**Prilagođavanje poslovnice Eurobanke EFG  
Ulica Vase Čarapića 4**

## **uočeni problemi:**

## 6. neodgovarajući nagib rampe

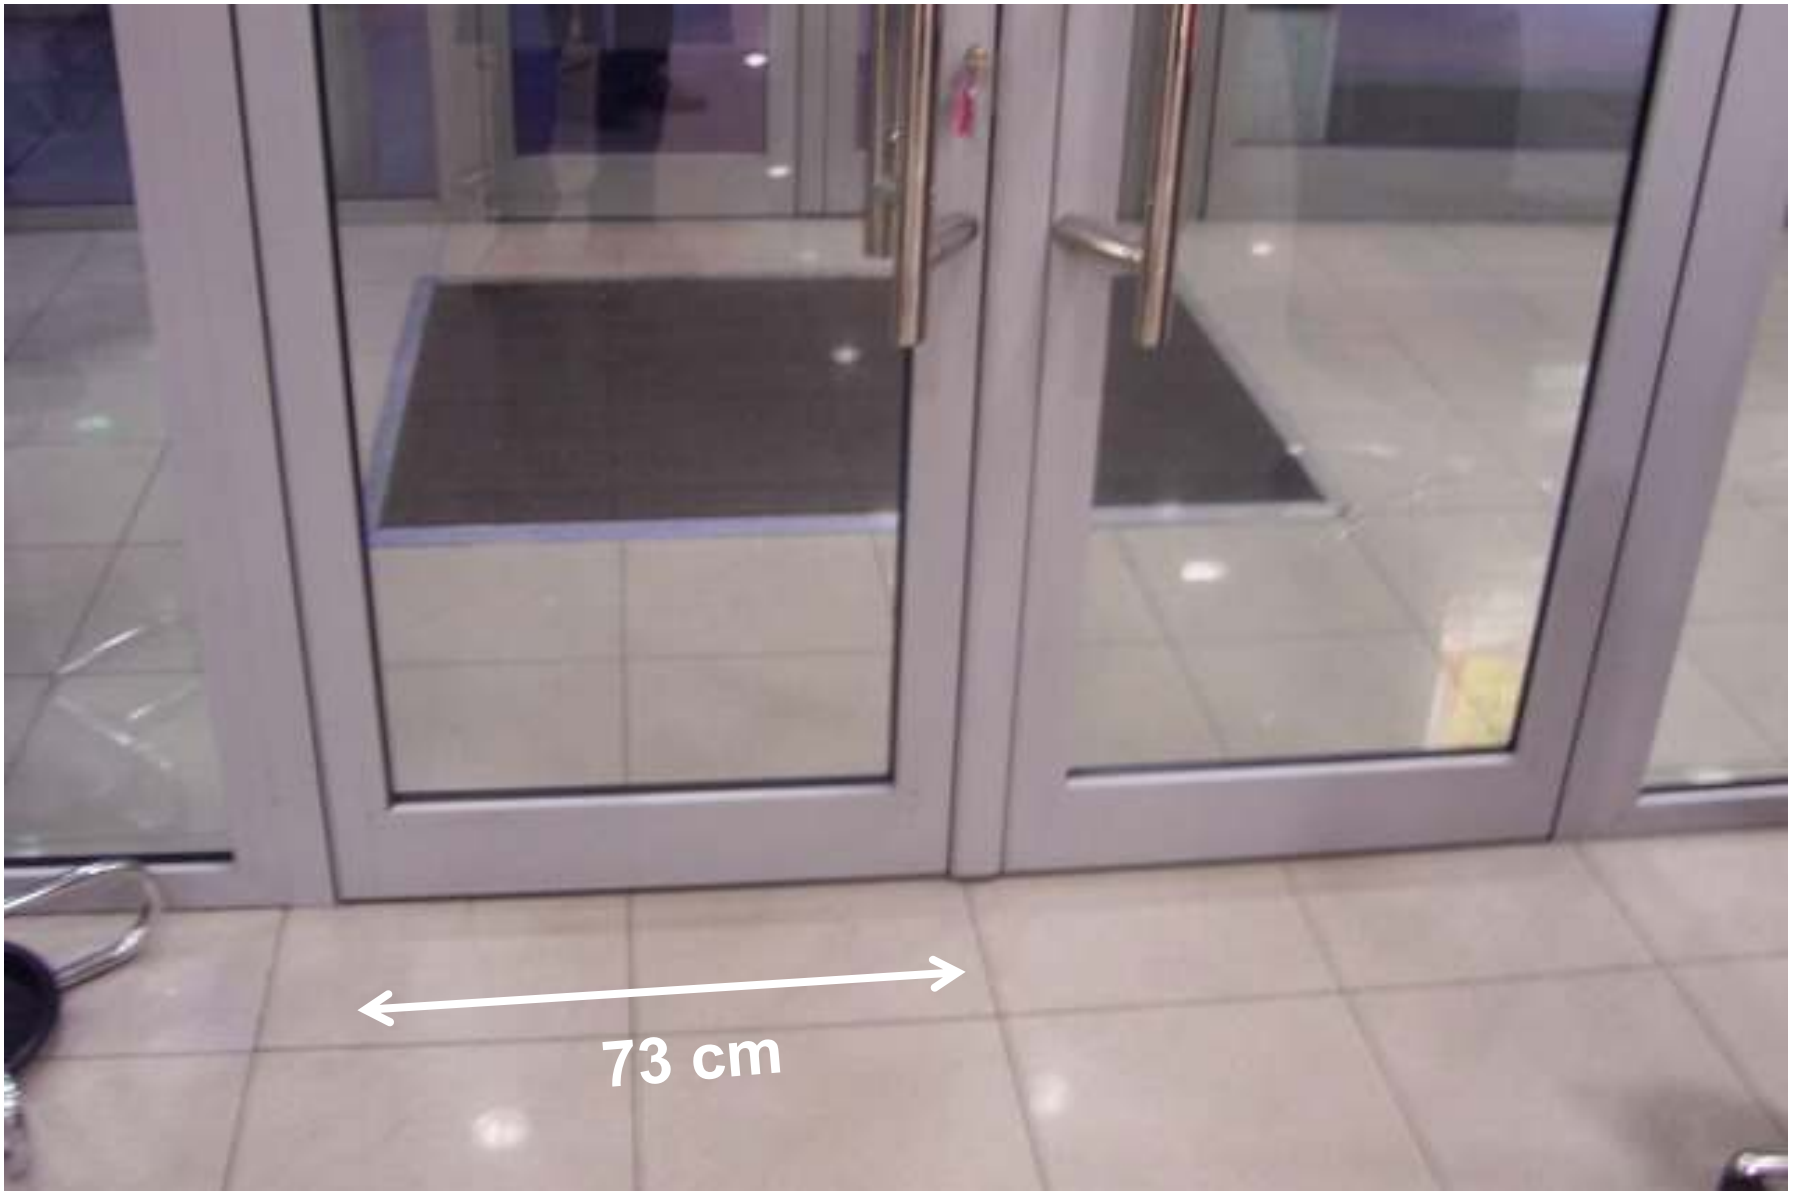
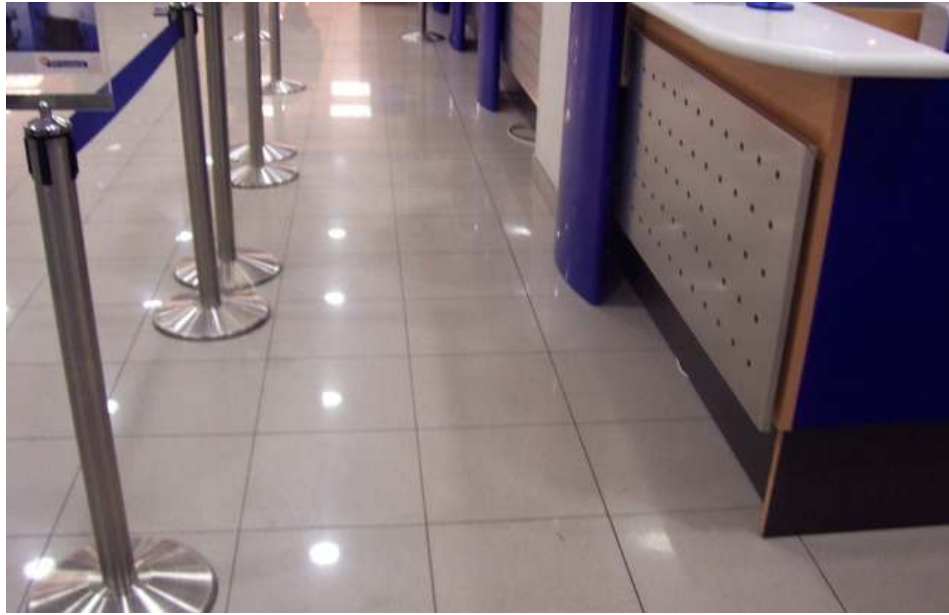
10 cm

350 cm

108 cm
